These units are interchangeable

Although the unit you purchased may not look exactly like the one removed from the vehicle, it will install and operate with no modifications necessary.

Fig. 1

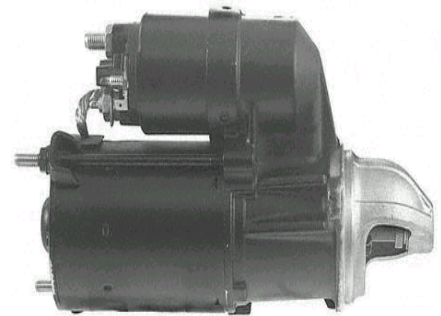
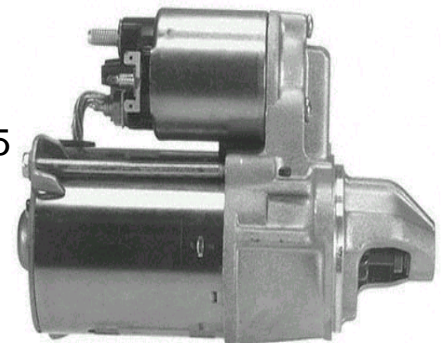
This is the original starter for '91 – '94. Because of the length of the starter, a rear support bracket is required. This starter is no longer available through Saturn. It has been superseded to the shorter DELCO or VALEO units shown below.

Figures 2 & 3 will replace Figure 1

This is the second version supplied by Saturn from '95 on. because of it being shorter, a rear support bracket is **not** needed.

**Figures 2 & 3
ARE COMPLETELY
INTERCHANGEABLE**
